SECTION 00 9112
ADDENDUM NUMBER 2

DATE: 03/02/2021
PROJECT: CITY OF MILLERSBURG FIRE STATION 15
ARCHITECT'S PROJECT NUMBER: 20006
OWNER: CITY OF MILLERSBURG
ARCHITECT: SODERSTROM ARCHITECTS

R1 ROOF ASSEMBLY
3" = 1'-0"

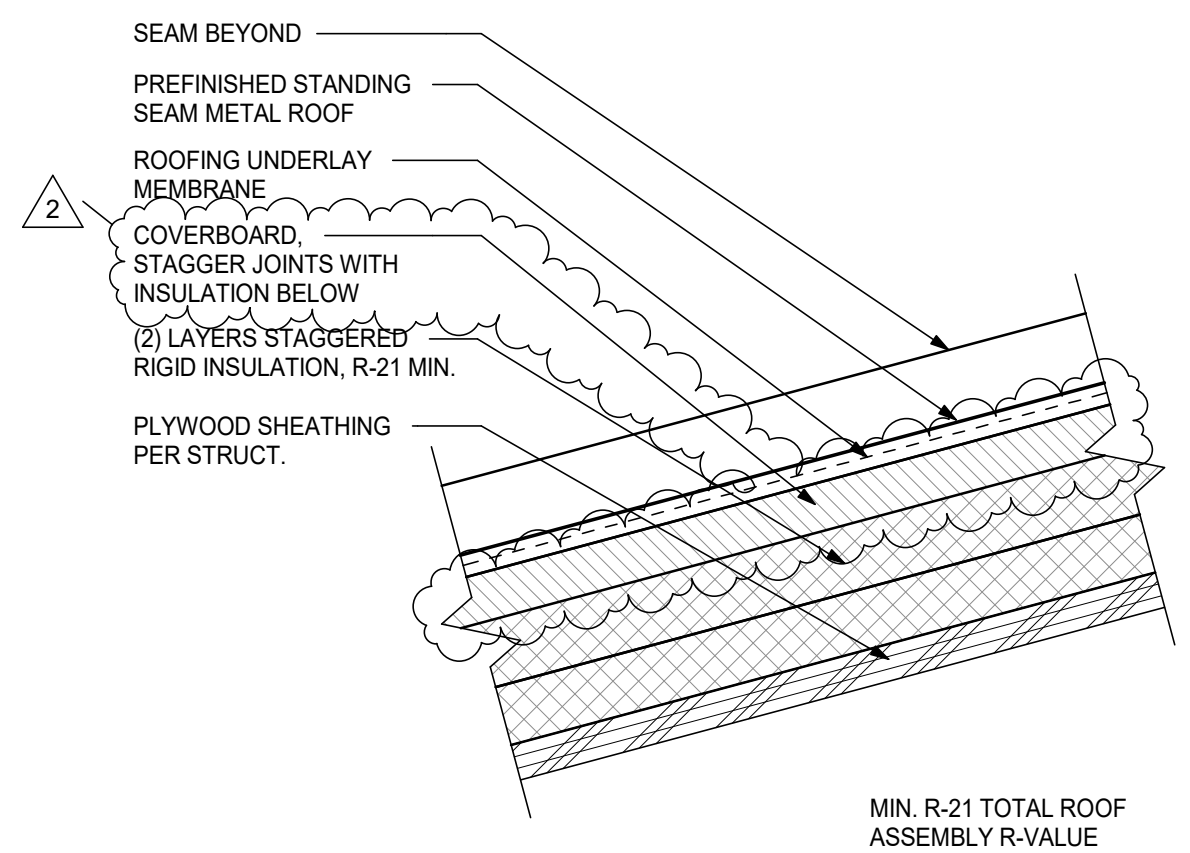
DRAWING R1/A0.01

Revise to show coverboard at rigid insulation

- 61. Detail R1 / A0.01 shows roofing underlayment attached to the rigid insulation and details on A8.20 shows ice & watershed over the underlayment. Please clarify how the underlayment and ice and water shield are attached and adhered to the insulation. This assembly generally requires z-furring and plywood sheathing over the insulation or a structural insulated panel (SIP) to be installed so that the weather barrier and metal panels have something to structurally adhere to.**

- A. A cover board has been added to the roof assembly to allow for adherence of underlayment and ice and water shield. See revised A0.01 and A8.20 reissued with this addendum.

1 OVERALL FLOOR PLAN

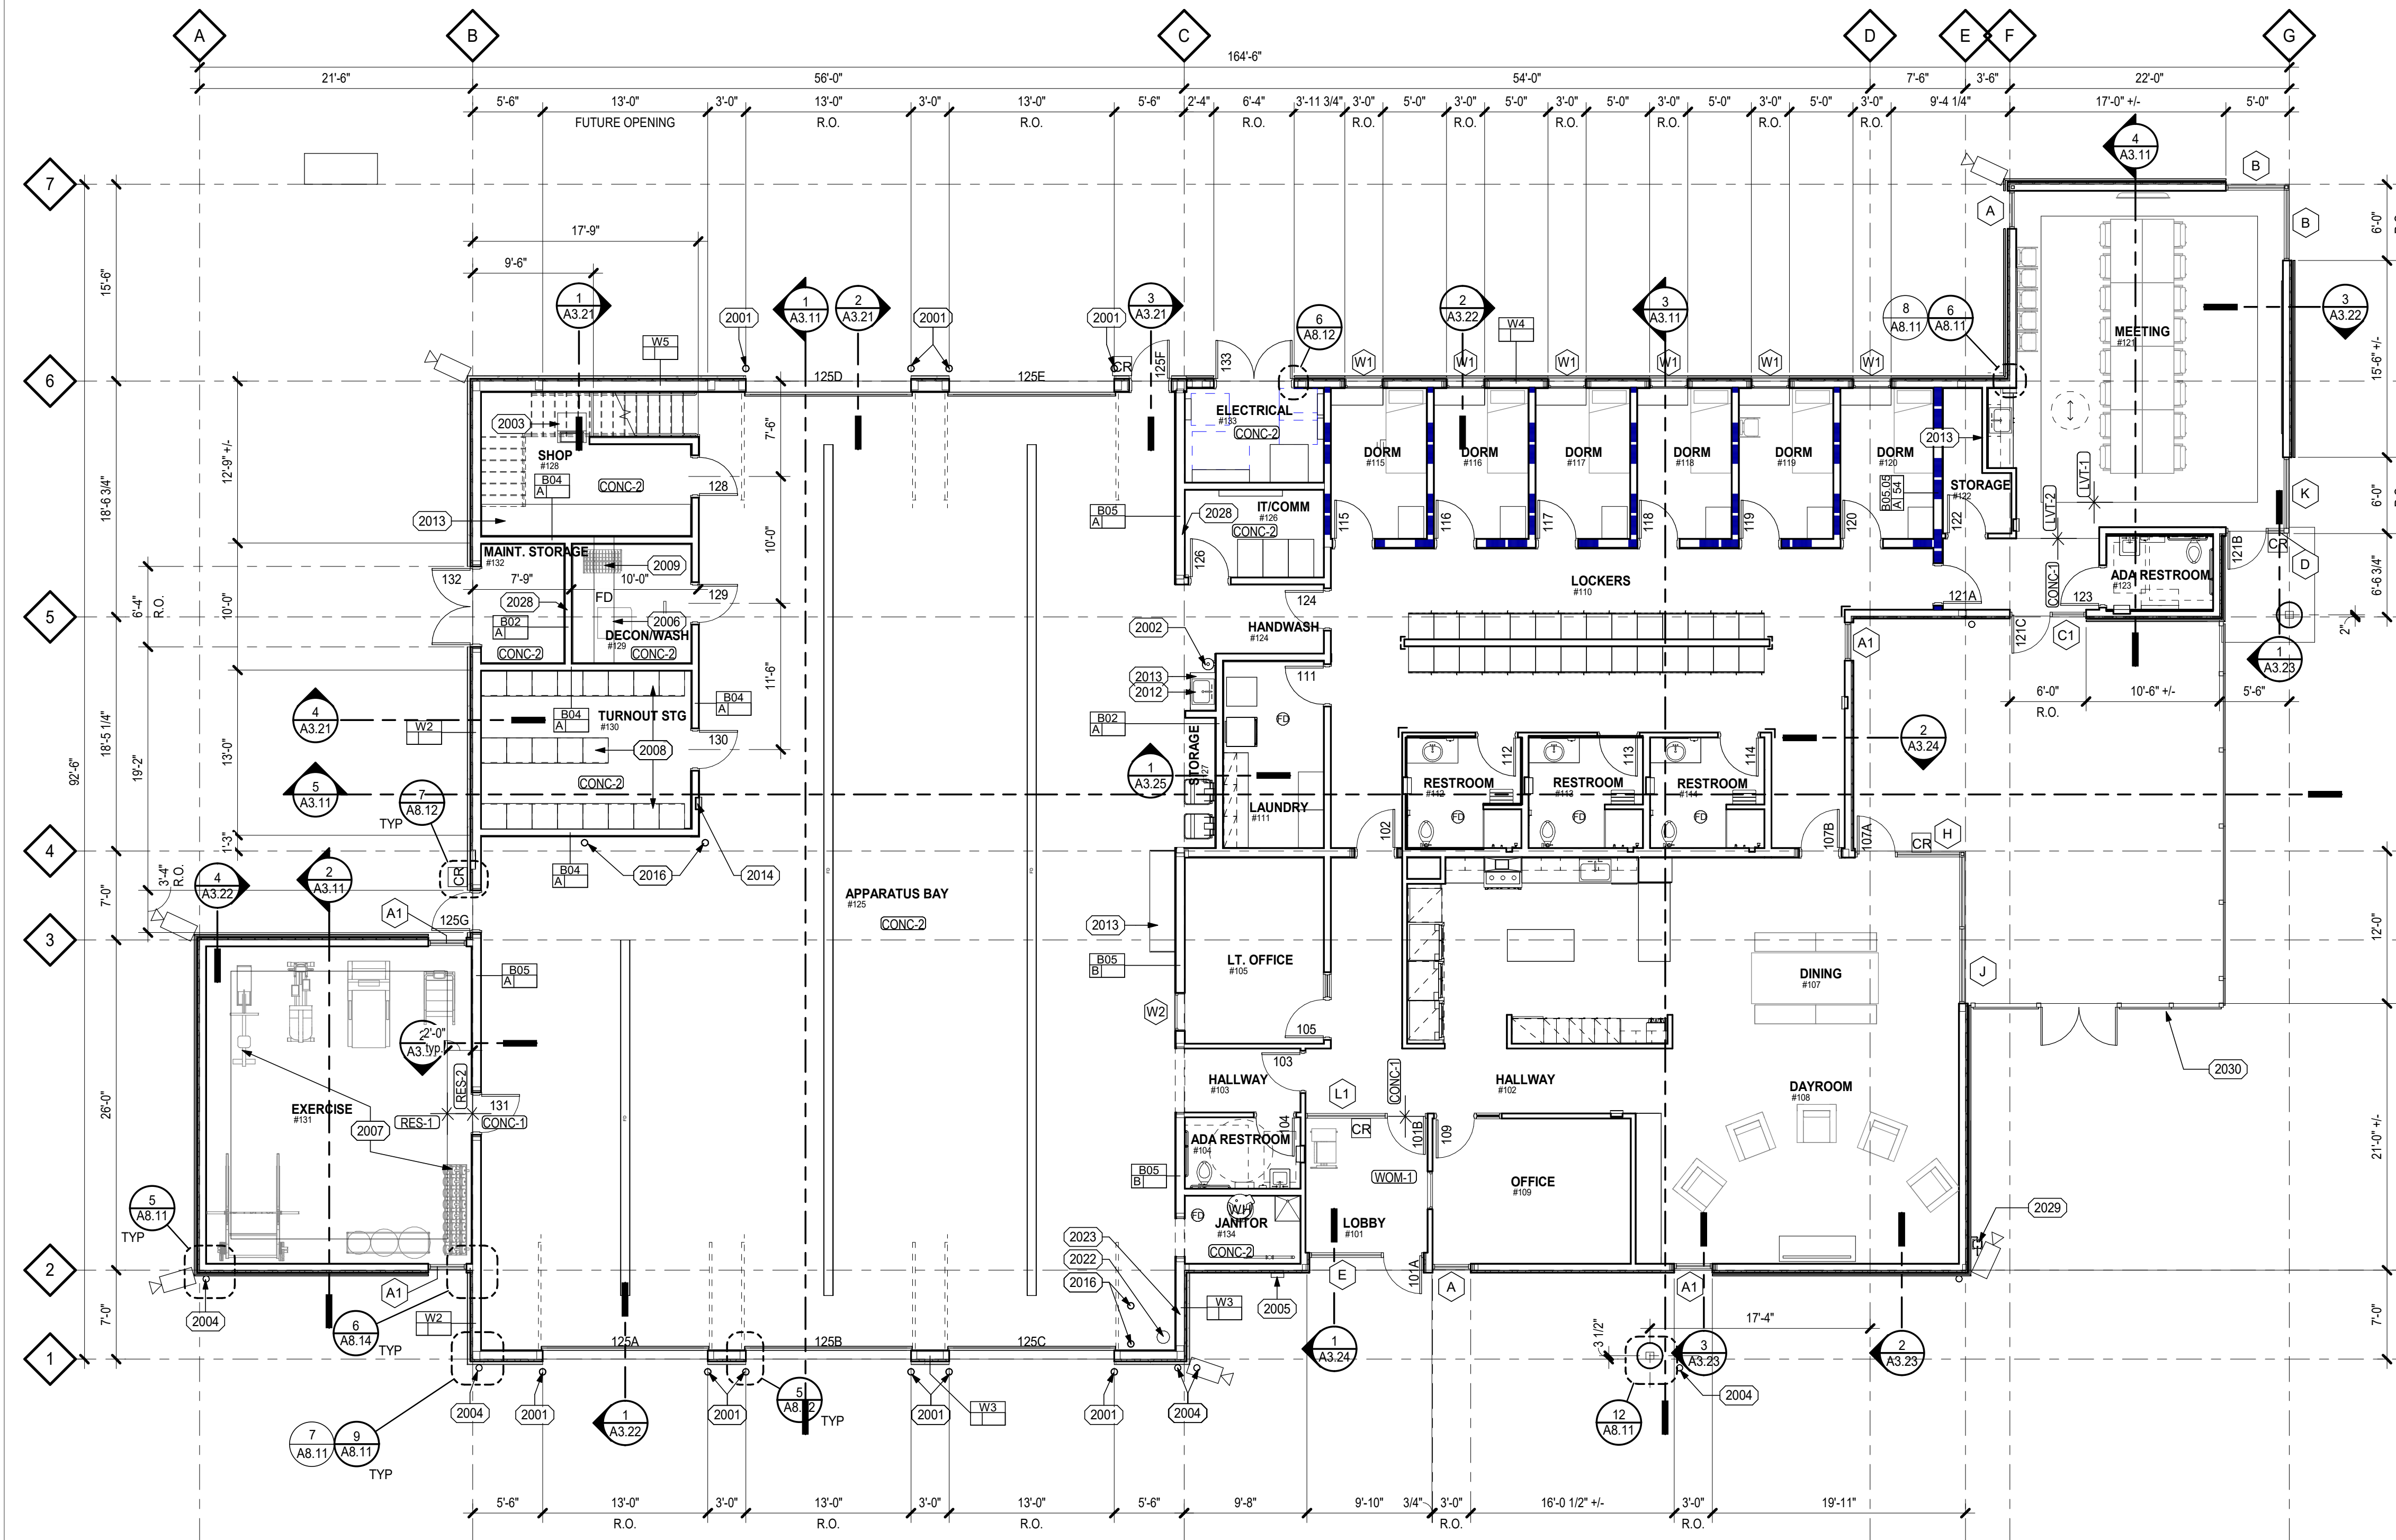
DRAWING A2.01

Added Note to sheet, as follows: Wall and building section cuts were inadvertently not shown on the previously issued version of this drawing. Cuts have been added to plan. Since the sections themselves are not new information, these cuts have not been clouded in order to maintain legibility of drawing.

Added Building and Wall Section cuts as noted above

1 LIVING QUARTERS PLAN
1/4" = 1'-0"

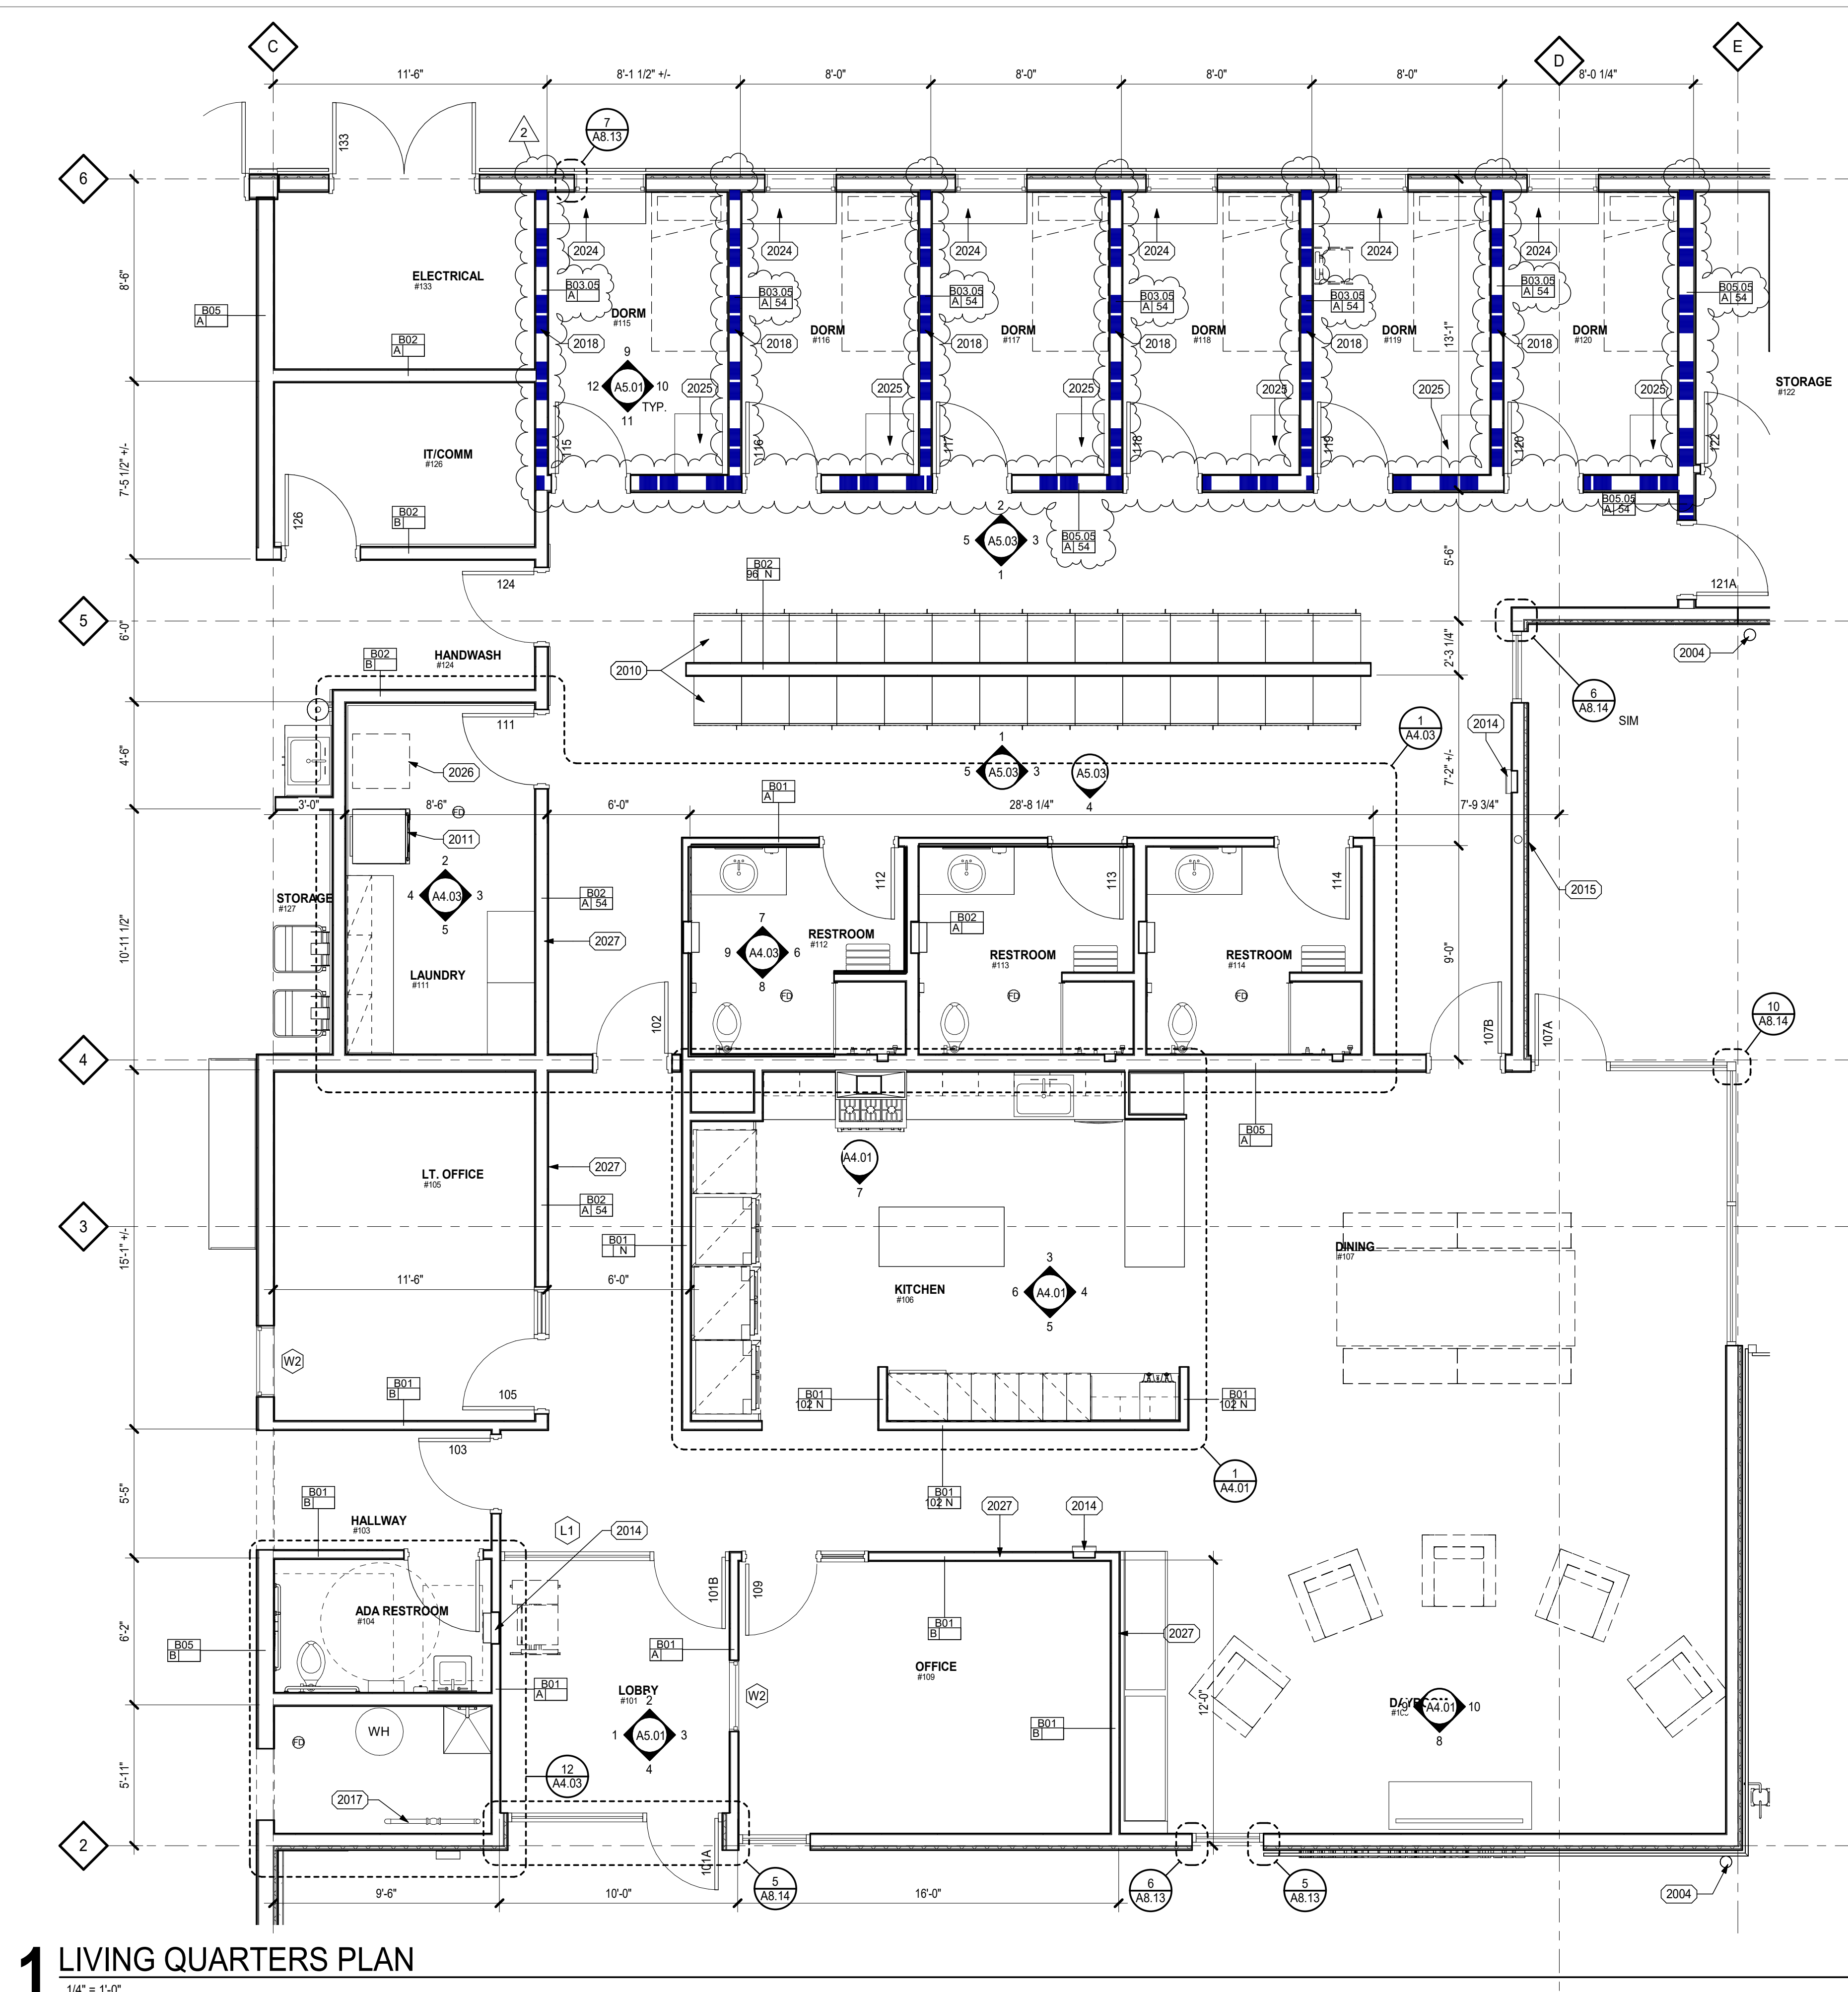
DRAWING 1/A2.02

Revise to indicate Dorm walls are Wall Type B03.05 and B05.05 at hallway, per clouded items, Delta 2.

- 36. Partition type B05 at the Dorms is noted on Interior Assemblies A0.11 with 2x8 studs and a 9" overall dimension = 5/8" gwb + 7 1/4" stud + 1/2" plywood + 5/8". The structural plans show these walls as S13 with a 2x6 stud on S2.01 and 1/S3.02. Please clarify stud size for shear wall type S13, and shear wall type between dorm rooms.**

- A. Dorm walls should be B03, which has 2x6 stud framing. See revised A2.02 included with this addendum.
- 37. Plywood walk path at dorms are shown on RCP, detail 3/A9.22. Please confirm 5/8" OSB is spanning between 2x6"s at 24" OC. Is a handrail required on the access pathway? If so, please provide blocking details.**

1 NORTH ELEVATION
1/8" = 1'-0"

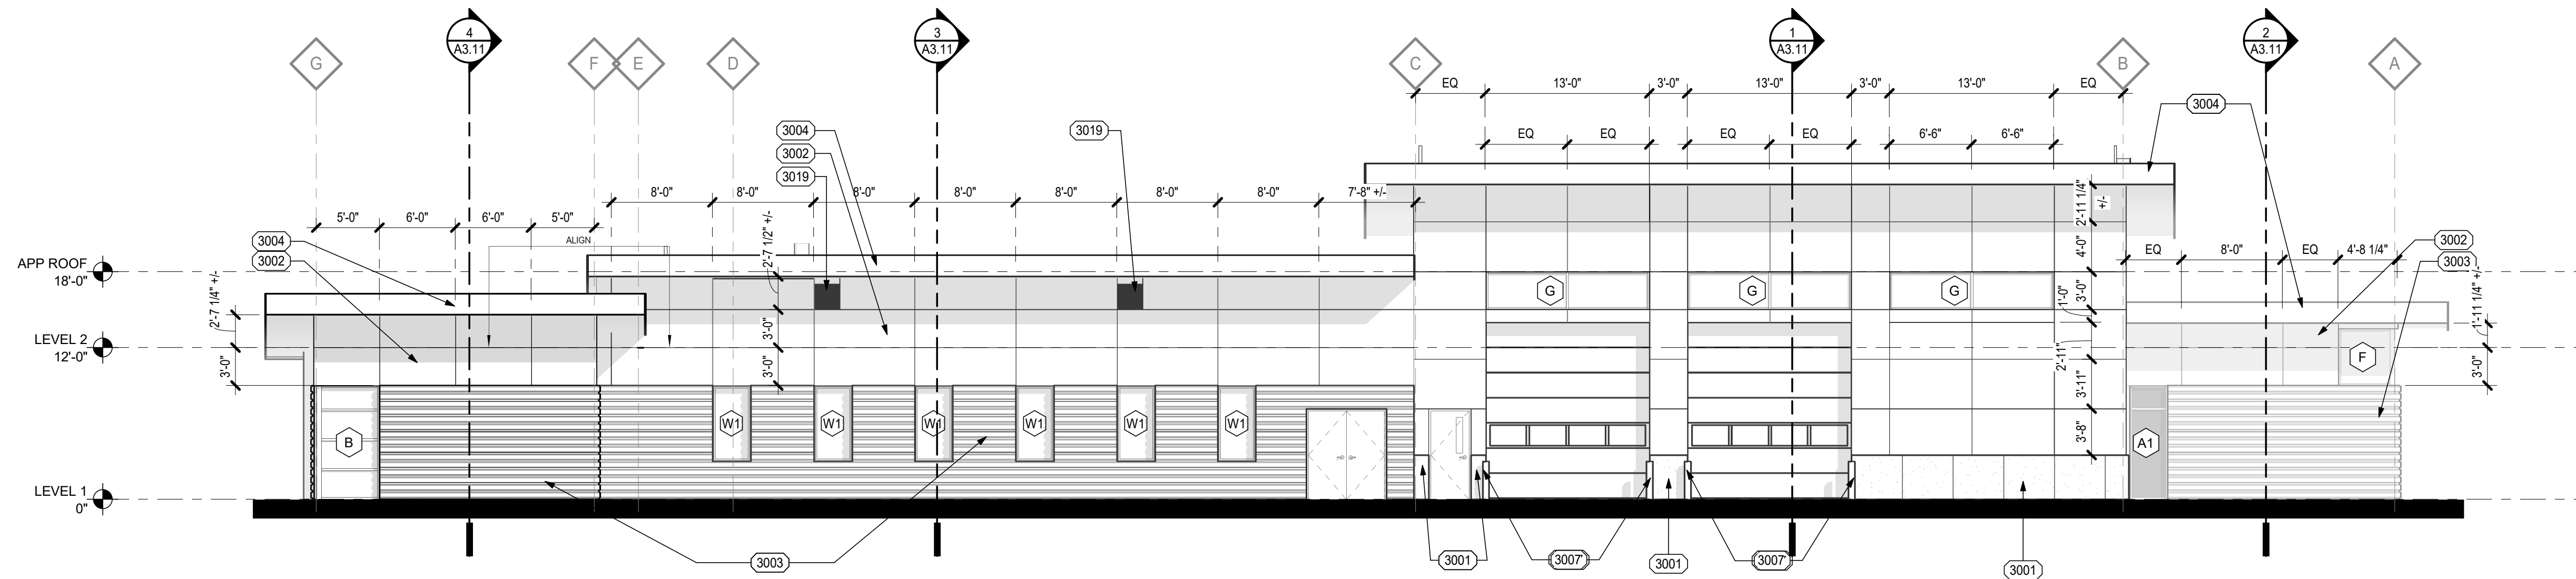
DRAWING A3.01

Revise Keynote 3004

- A. A 20" high LSL board will be used for fascia board at all locations. See revised details on A8.20 and revised Keynote 3004 on A3.01 and A3.02, reissued with this addendum.
